CROCKETT COGENERATION PROJECT
(92-AFC-1C)

PETITION TO AMEND
THE CALIFORNIA ENERGY COMMISSION
FINAL DECISION

SUPPLEMENTAL DATA
SUBMITTED JANUARY 12-20, 2012

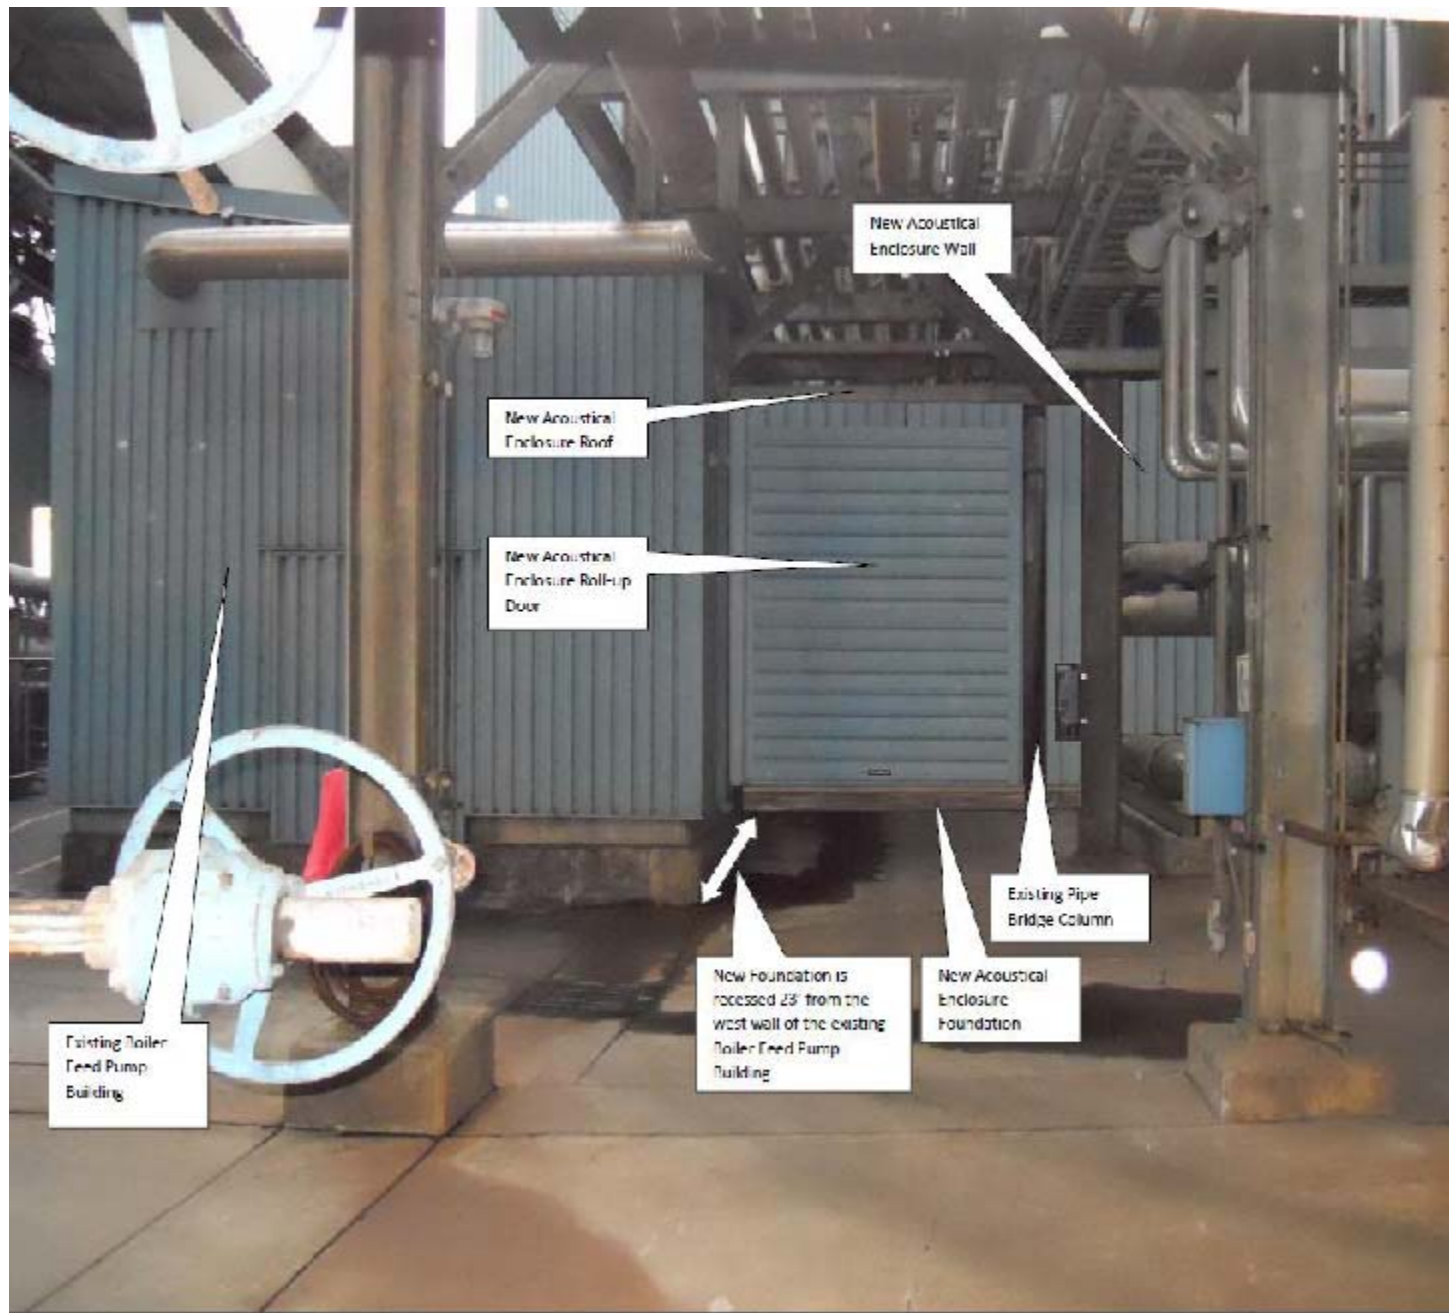
Question 1: Can you provide height information about the equipment and a conceptual elevation depicting how the equipment will fit in with the existing facilities where the equipment is proposed to be located?

Answer : The height of the acoustical enclosure will be approximately 12 feet with a sloping roof.

I am attaching two files showing the compressor location before and after. As you can see, this spot is tucked in an area making views of it from a decent distance almost non-existent. This is the only decent location to shoot a photo and do a rendering from. This also demonstrates just how invisible the compression equipment will be to the outside world. It is dwarfed and surrounded by taller equipment/structures.

See attachments 1 and 2: Proposed Compressor Location (current) and Proposed Compressor Location (rendering).

| SHEET TITLE: FOUNDATION PLAN OPTION 2 | |

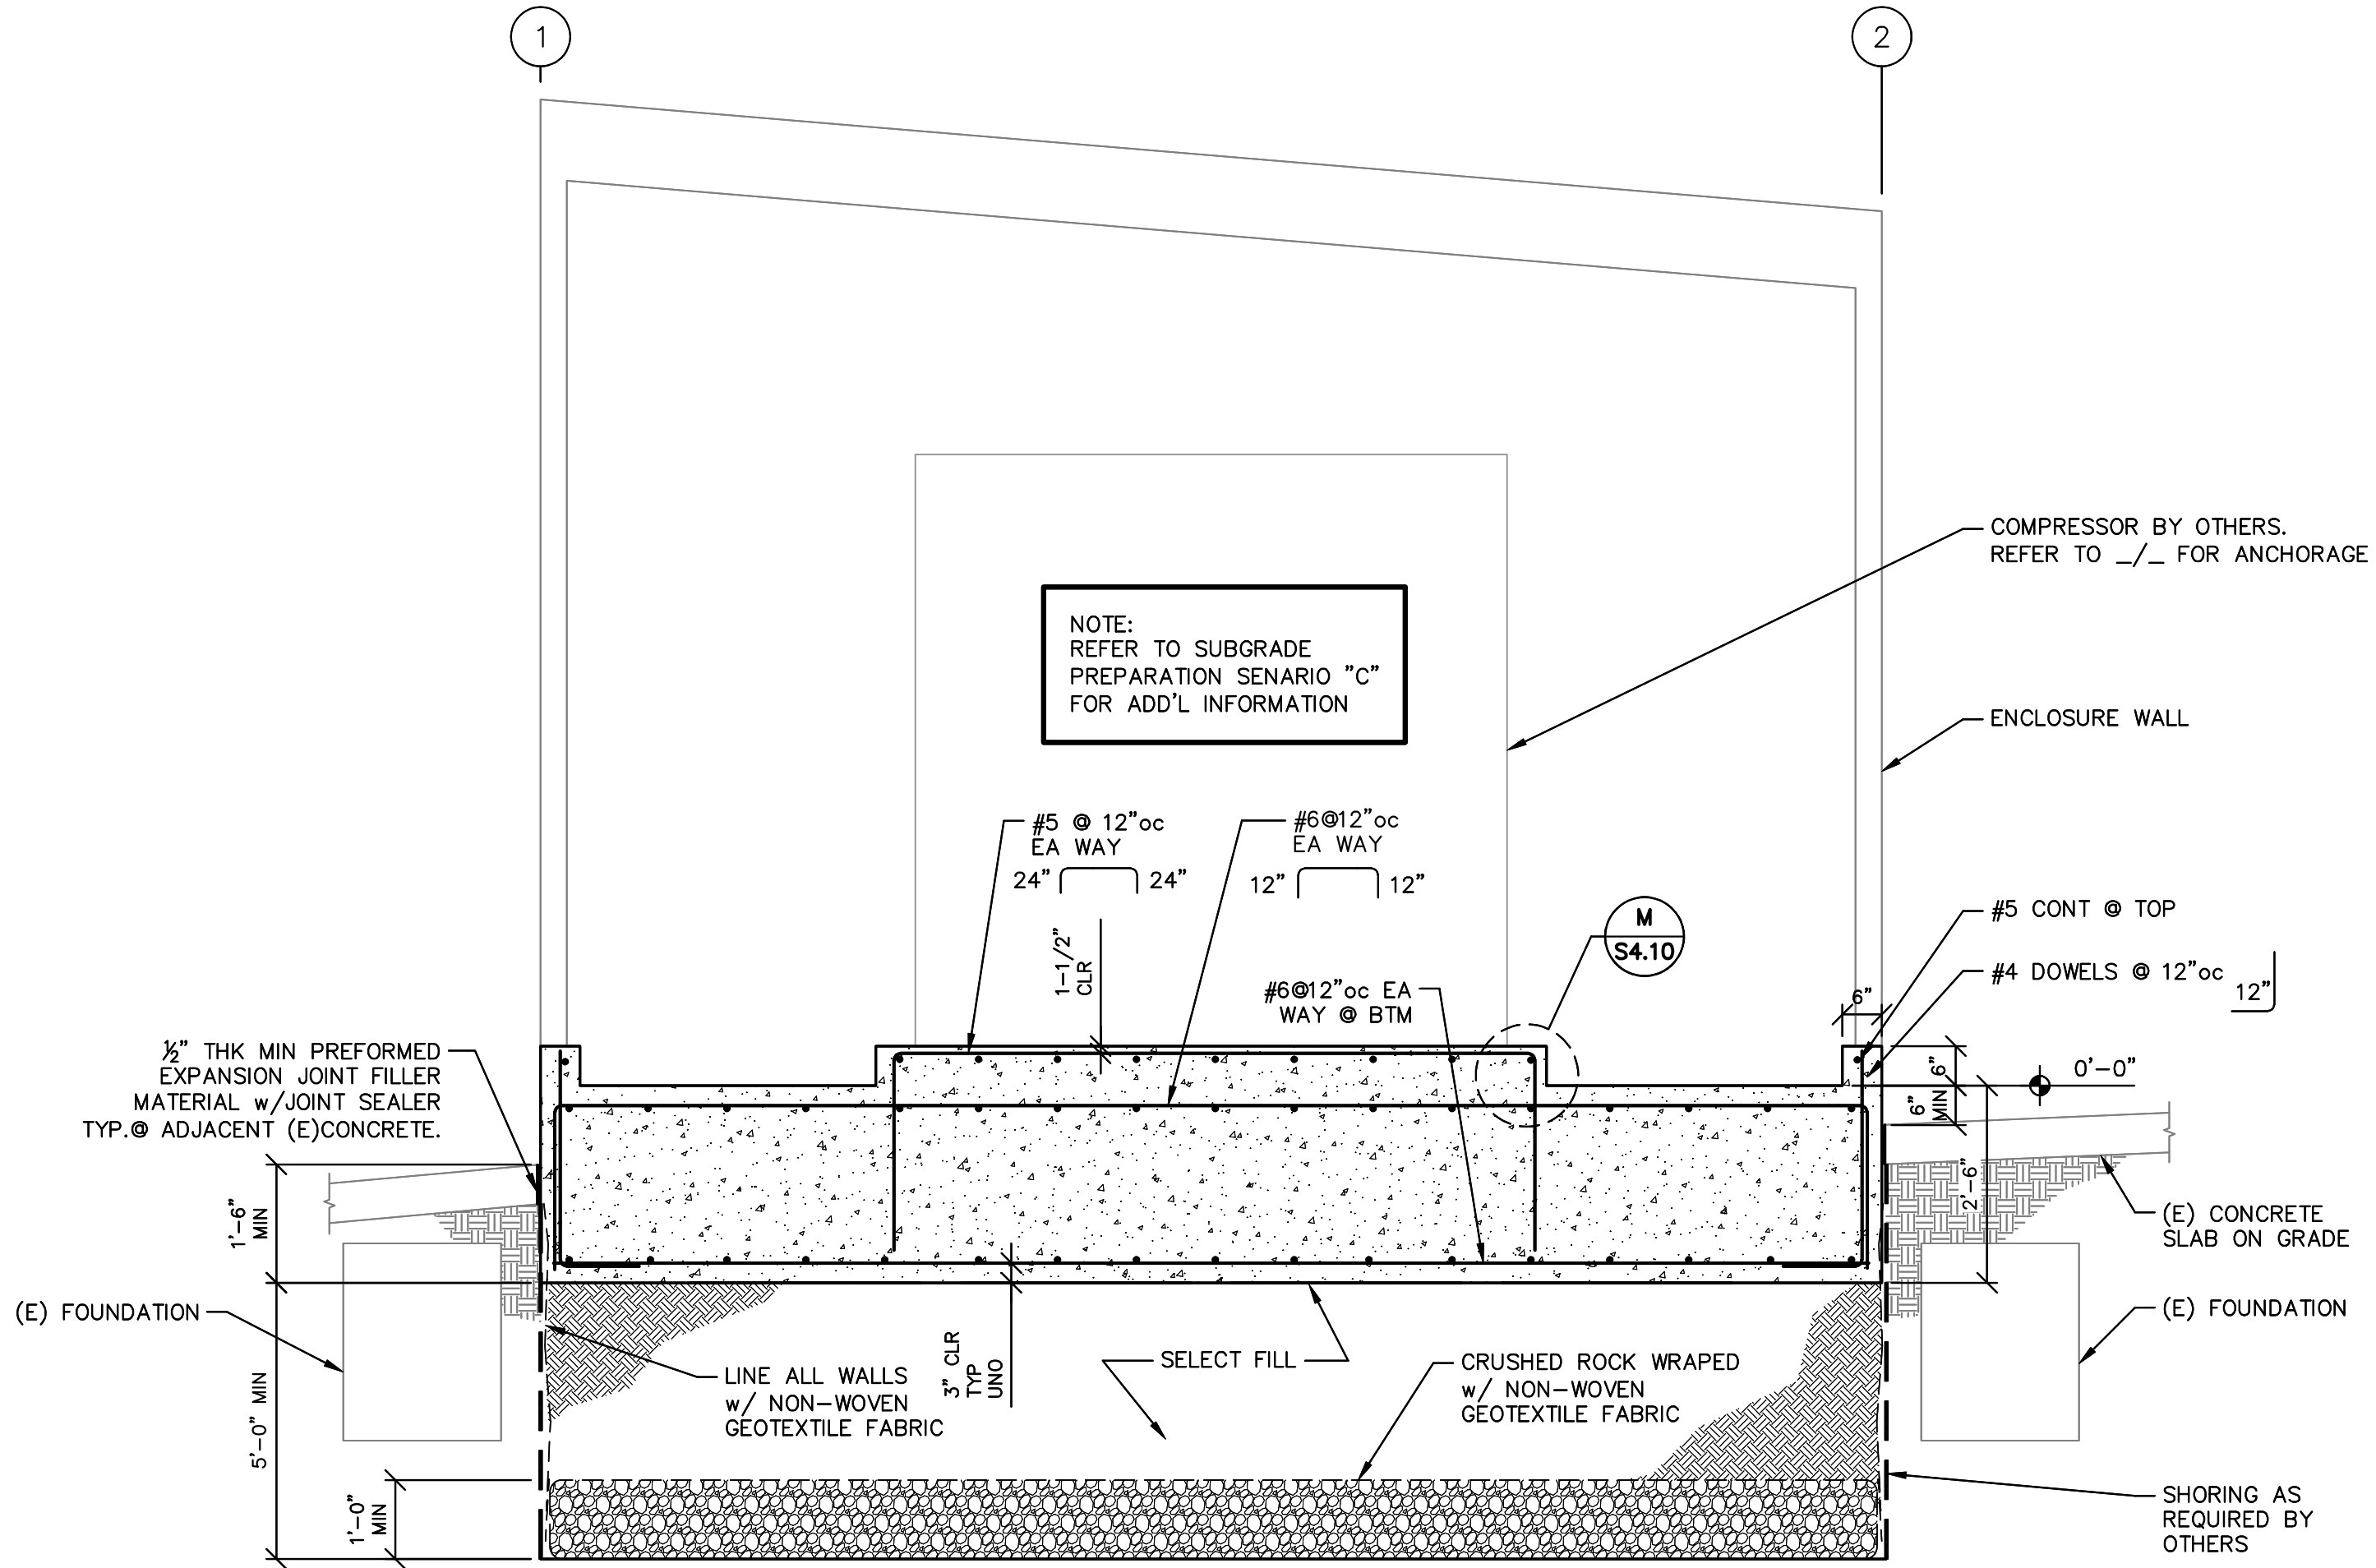
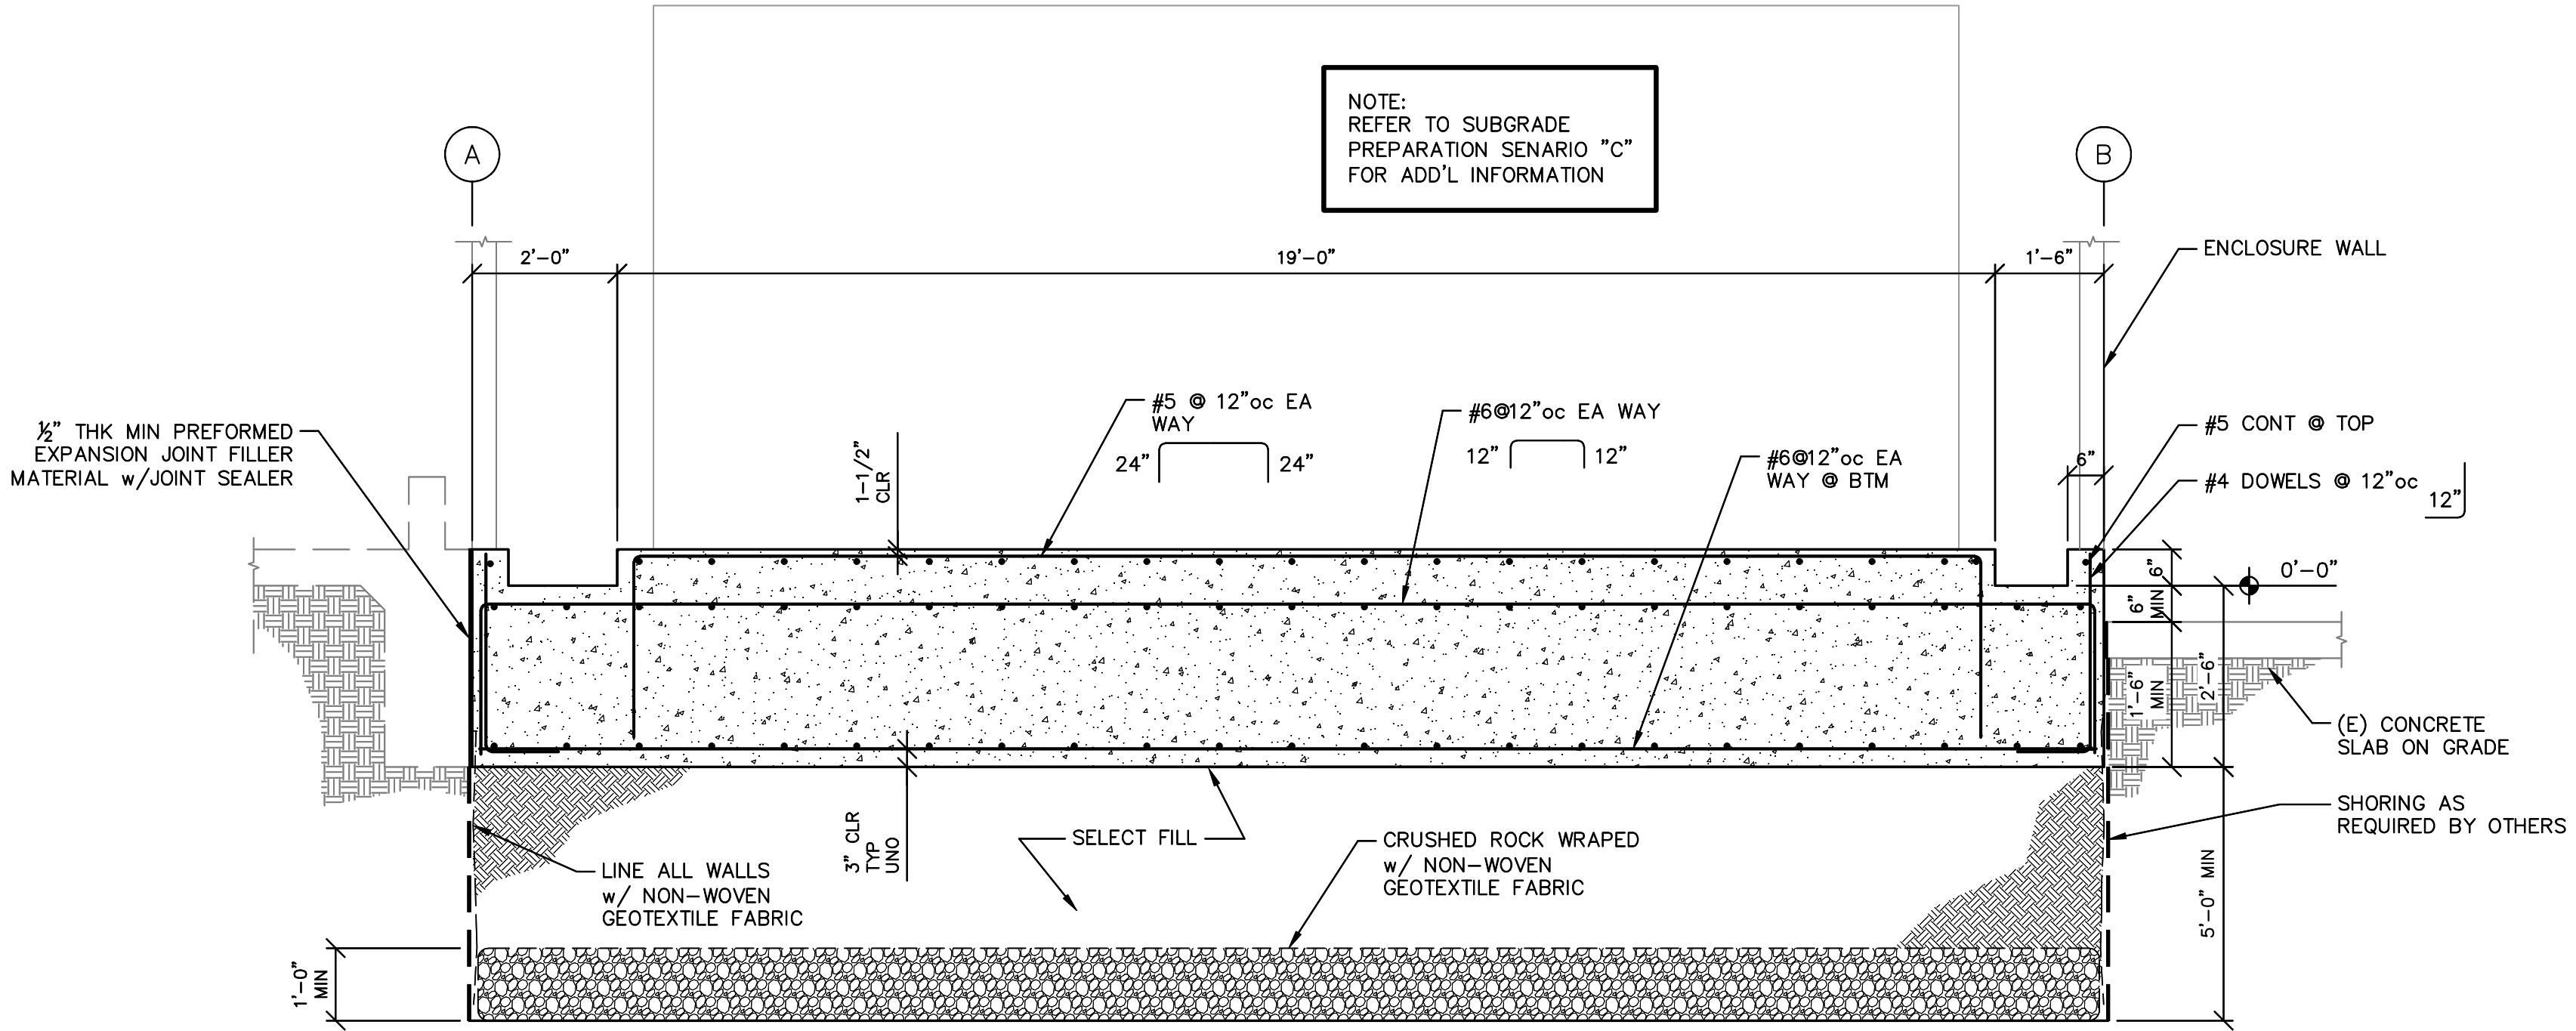
Question Geo-3: Please provide the following:

- 1) a detailed description of the "micro piles"
- 2) the method of installation of the micro piles
- 3) whether or not the micro piles will extend into stiff native soils
- 4) whether or not the micro piles are to be constructed in drill borings
- 5) address provision of information for soil characterization and subsequent disposal methods of the drillspoils (as applicable).

- 1) No micro piles will be used in the chosen foundation. The foundation will be Option 2 detailed on drawing S2.15. Project owner should get final foundation drawings from Project owner's engineering consultant, Cannon Corp., by January 27, 2012.
- 2) N/A. See response to question 1, above.
- 3) N/A. See response to question 1, above.
- 4) N/A. See response to question 1, above.
- 5) Amec, the project owner's geotechnical consultant, has been contracted to do boring, sampling and testing of the existing soil for waste characterization in the event that some of the soil needs to be landfilled. In the event that excavated soil needs to be landfilled, if such soil is determined to be hazardous it will be sent to US Ecology, Inc.'s Hazardous Waste Treatment and Disposal Facility located in Beatty, Nevada.

If some of the excavated soil needs to be landfilled and it is not characterized as hazardous, it will be transported to the Canyon landfill located in Pittsburg, California for disposal. According to the foundation Design (Option 2, Drawing S2.15), the maximum estimated amount of soil that may need to be landfilled is approximately 2,700 cubic feet. This is approximately 5 truckloads of soil. Please note that it is project owner's
